West Wyalong Solar Farm Modification 1

Road upgrades
State Significant Development Modification Assessment
(SSD 9504 MOD 1)

September 2021

Figure 2 | Approved road upgrades and site access

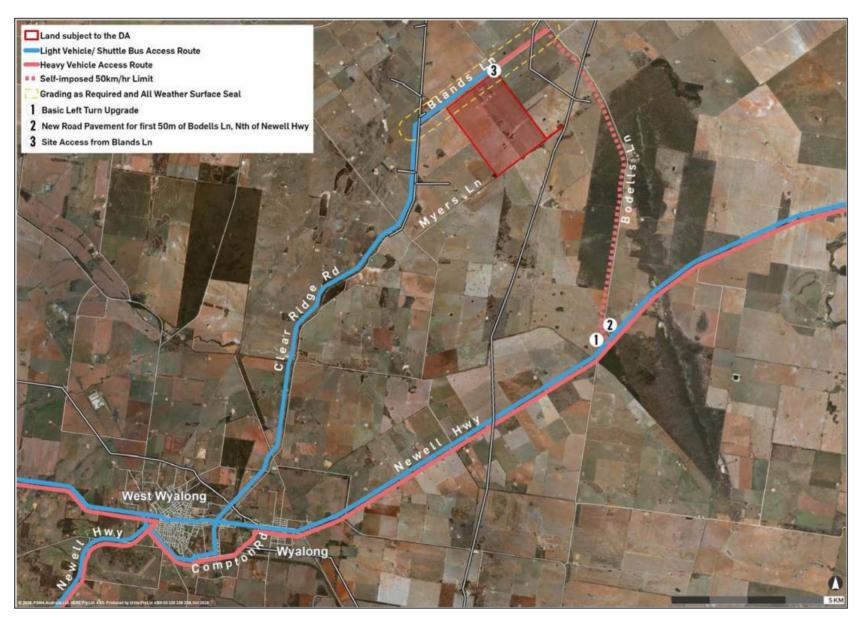
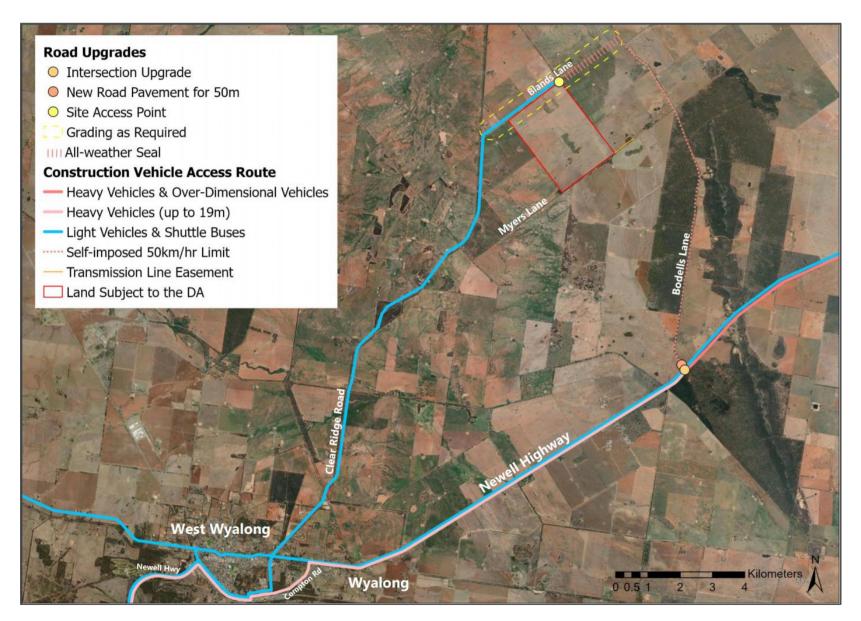
The proposed modification application seeks to make changes to the access route and road upgrade requirements including removal of a Basic Left Turn treatment at the intersection of Newell Highway and Bodells Lane, changes to the access route for heavy and over-dimensional vehicles, and removal of the requirement to include an all-weather seal on Blands Lane between Clear Ridge Road and the site access point.

The approved and proposed road upgrades and site access maps are shown in **Figure 2** and **Figure 3** respectively.

The existing development consent requires road upgrades to be undertaken on Blands Lane between Bodells Lane and Clear Ridge Road, including grading and an all-weather seal. Initially, the modification application sought to reduce the scope of the road upgrade to be between Bodells Lane and the site access point and remove the requirement to include grading and an all-weather seal.

Road section – Blands Lane	Road upgrades – original proposal	Council concerns	Road upgrades - amended proposal
Bodells Lane to site access point	Remove requirement to include grading and an all-weather seal in upgrade	Suitability of the road treatment with regards to heavy and over-dimensional vehicle usage	Include grading and an all-weather seal as per original condition
Site access point to Clear Ridge Road	Remove requirement to upgrade	Accessibility for light vehicles and shuttle buses	Include grading but remove requirement for all-weather seal

The amended treatment proposed for Blands Lane is considered appropriate as it provides a graded and sealed access route for heavy vehicles approaching from the east and graded access for light vehicles approaching from the west.

The proposed modification seeks to remove the requirement to include a BAL treatment at the intersection of Bodells Lane and the Newell Highway, and instead require road upgrades to cater for the largest vehicle accessing the site. The BAL treatment was no longer required because vehicles greater than 19 m in length would be restricted from accessing the site via the Newell Highway southwest, as per advice from TfNSW.
